July 2015 Board Update

Hardin County Board of Education

Addendum #1

Project Name: New Highland and North Park Elem.
Schools Entry Vestibules MGT# 1509

ADDENDUM DWG
AD1.1

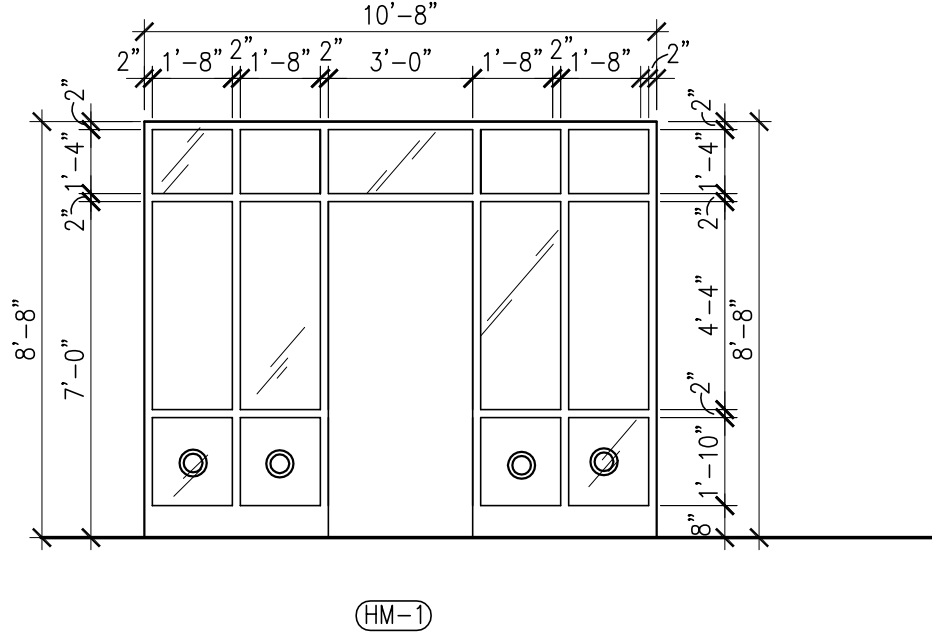
- a. **Sheet A1.0**, drawings 2. Please find a new layout for the Admin Office, **AD1.1**, including a 42" high partition wall. New wall to be primed and painted; coordinate paint color with the owner. Furniture is owner provided. Door 103 has moved, resulting in a new HM-1, **AD1.2**.

- 1.04 New Highland Elementary - Refer to the Revised Architectural Drawing AD1.1, issued as part of Addendum #1.
 - At the New Workstation located along the South wall of Admin Room 103 – furnish and install the following utilities:

1.05 New Highland Elementary - Refer to the Revised Architectural Drawing AD1.1, issued as part of Addendum #1.

12. NEW 42" TALL 3 5/8" STUD WALL, WITH 5/8" GYP. BD. EACH SIDE.

ADDENDUM DWG

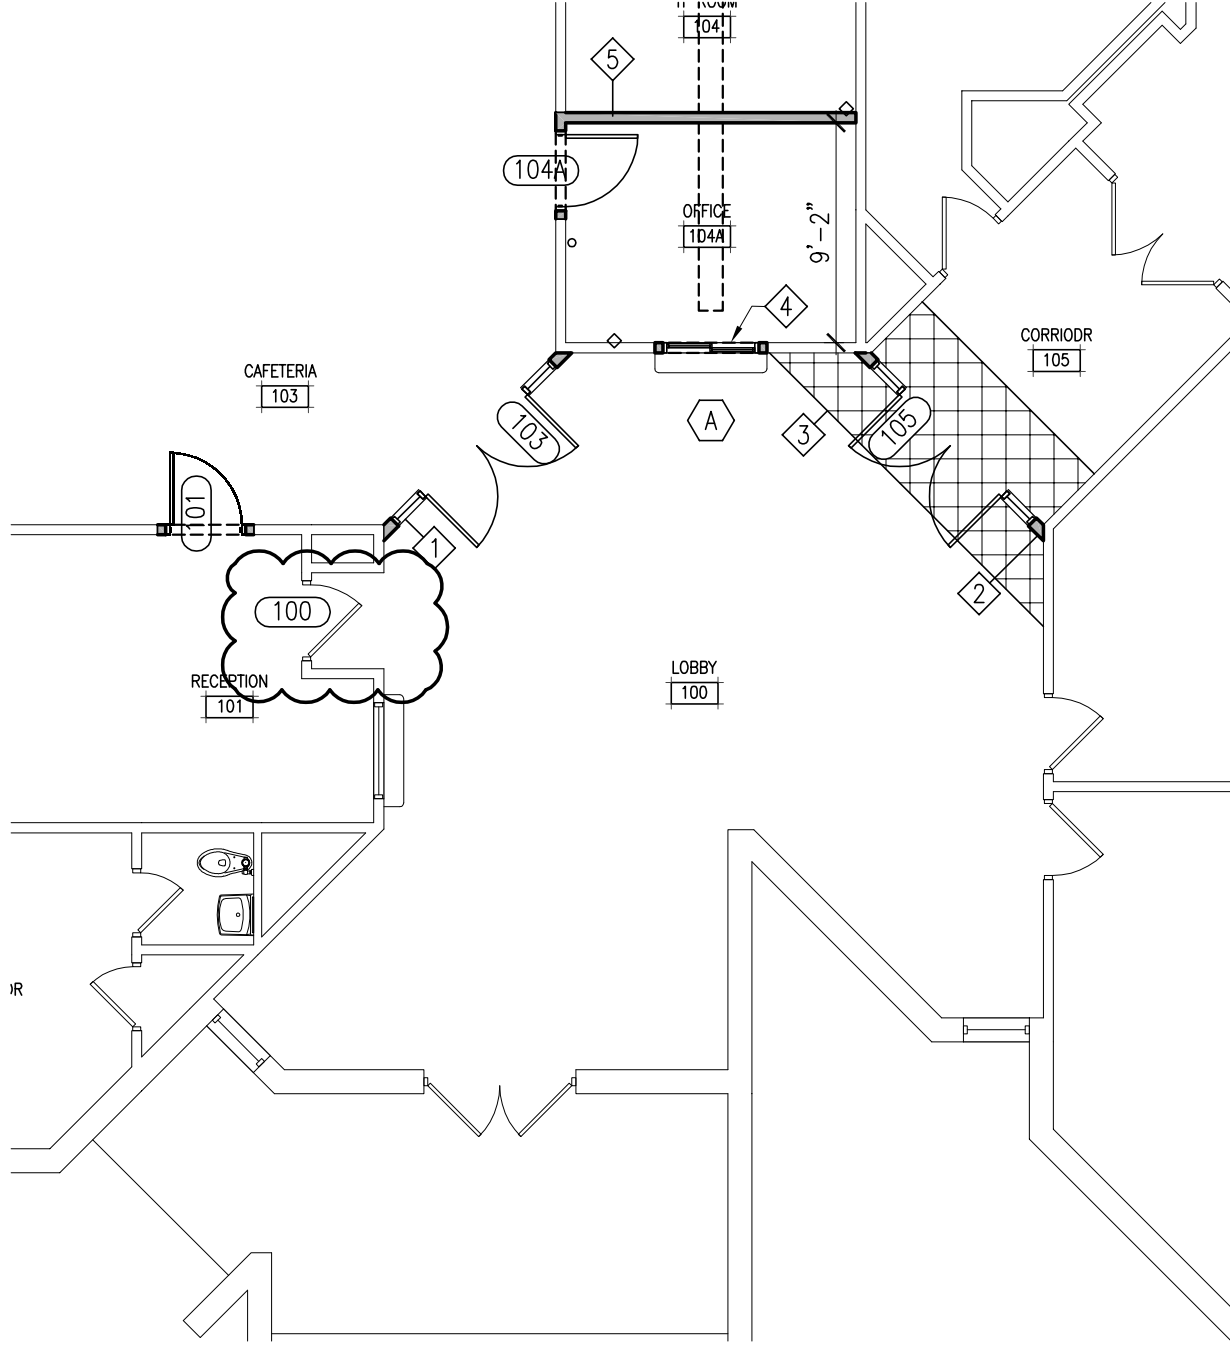
- a. **Sheet A1.0**, drawings 2. The existing door from Lobby 100 into Reception 101 has been labeled '100'. Please see the attached revised door schedule and MPE addendum.

EXISTING DOOR 100 OF LOBBY 100

SHEET
XME1.0

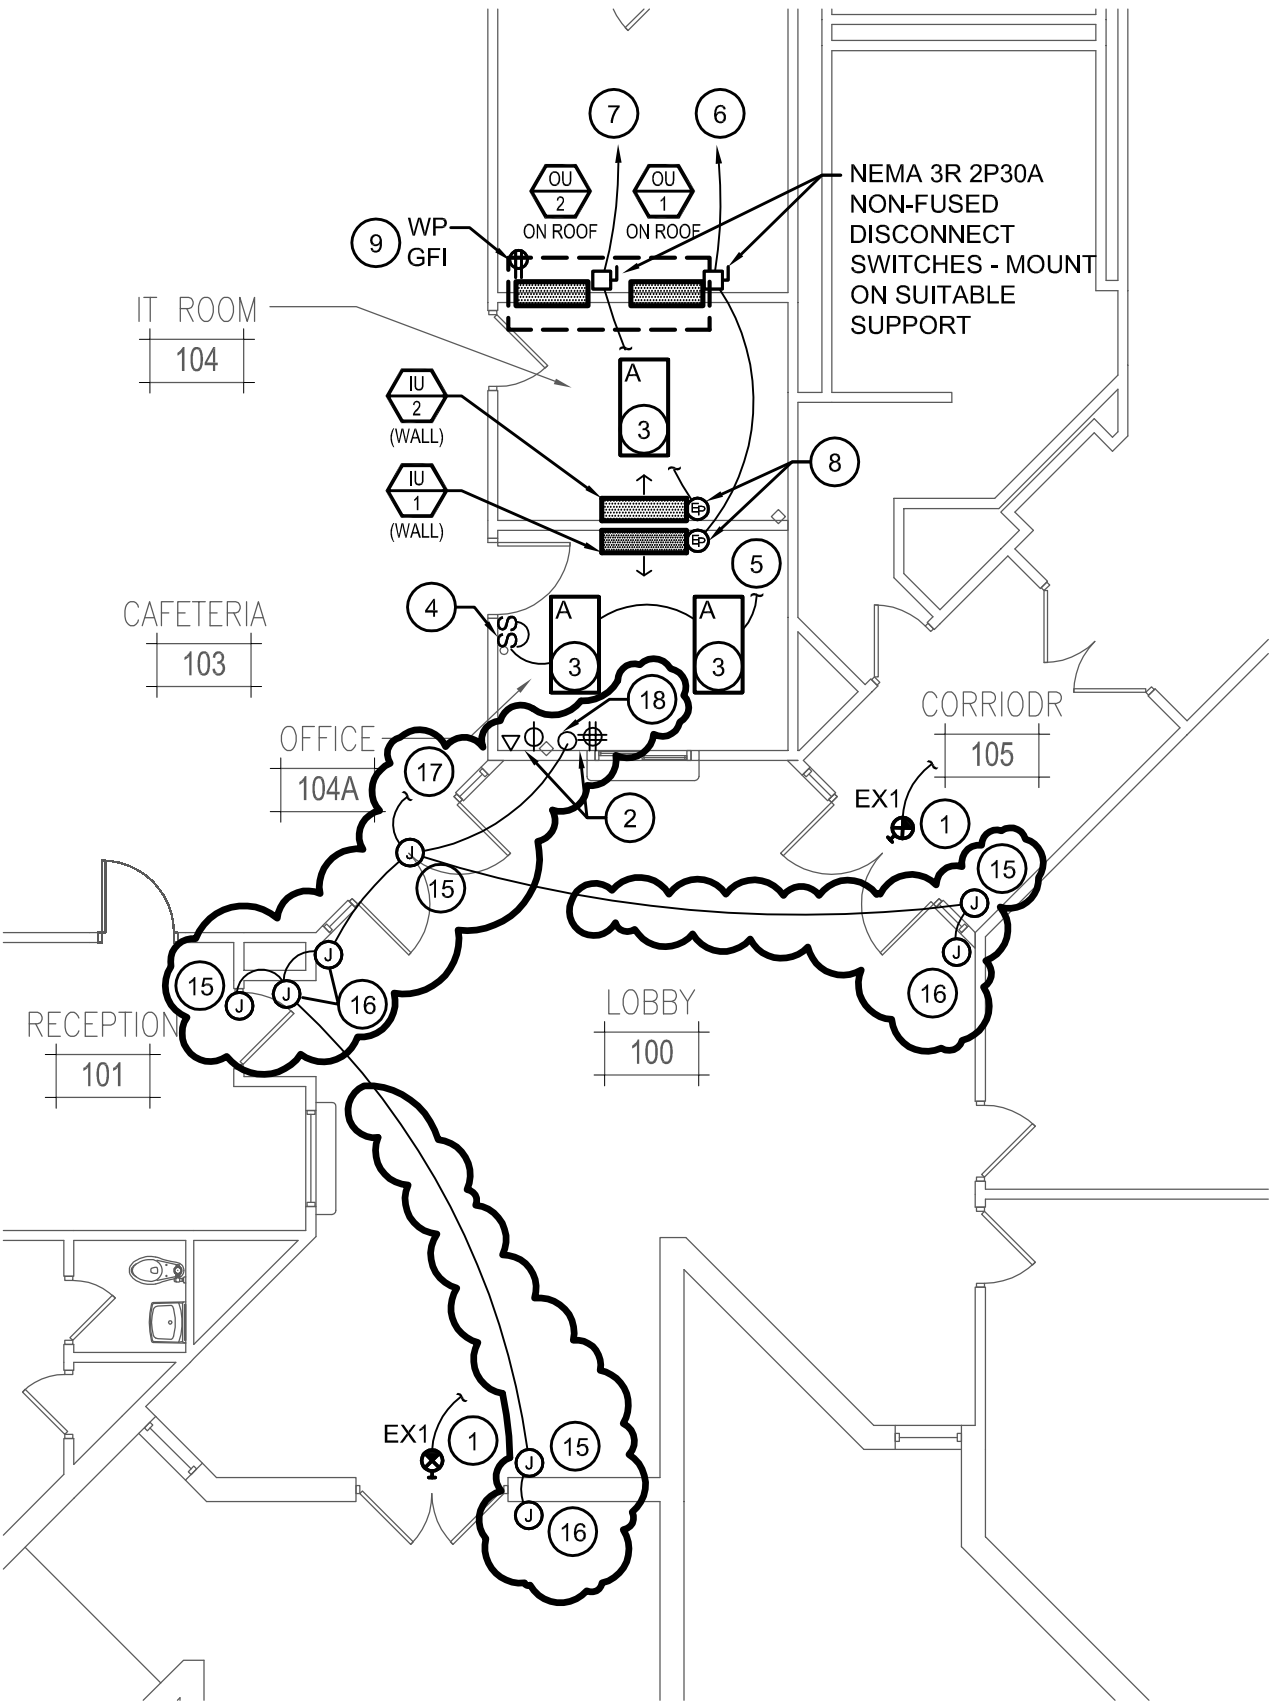
- 1.02 North Park Elementary – Refer to Sketch XME1.0 attached. Furnish and install all connections associated with door hardware controls – refer to Architectural Door Hardware Specifications.

#	(APPLIES TO THIS DRAWING ONLY)
15	J-BOX/CONDUIT DROP FOR CONNECTION TO ELECTRIC STRIKE POWER TRANSFORMER. FURNISH AND INSTALL ALL CONDUIT AND CONNECTIONS REQUIRED BY ARCHITECTURAL DOOR HARDWARE. 1/2"C-3#12 AWG FOR 120V WIRING CONNECTIONS.
16	J-BOX AND 1/2" CONDUIT DROP FOR CONNECTION TO CARDREADER. FURNISH AND INSTALL ALL CONDUIT AND CONNECTIONS REQUIRED BY ARCHITECTURAL DOOR HARDWARE.
17	FURNISH AND INSTALL 1/2"C-3#12 AWG FOR 120V WIRING CONNECTIONS FOR DOOR HARDWARE SYSTEM - CONNECT TO NEAREST AVAILABLE UNSWITCHED 120V. POWER SOURCE.
18	EXTEND CONDUIT AND CABLING CONNECTIONS TO EXISTING AIPHONE SYSTEM AND CONNECT SUCH THAT SYSTEM CONTROLS ELECTRIC STRIKE OF NEW DOOR HARDWARE. REMOVE THE EXISTING RY24DL RELAY FOR THE SYSTEM AND INSTALL A NEW (3) THREE DOOR RELAY (RY3DL) FOR CONTROL OF (3) THREE DOORS.
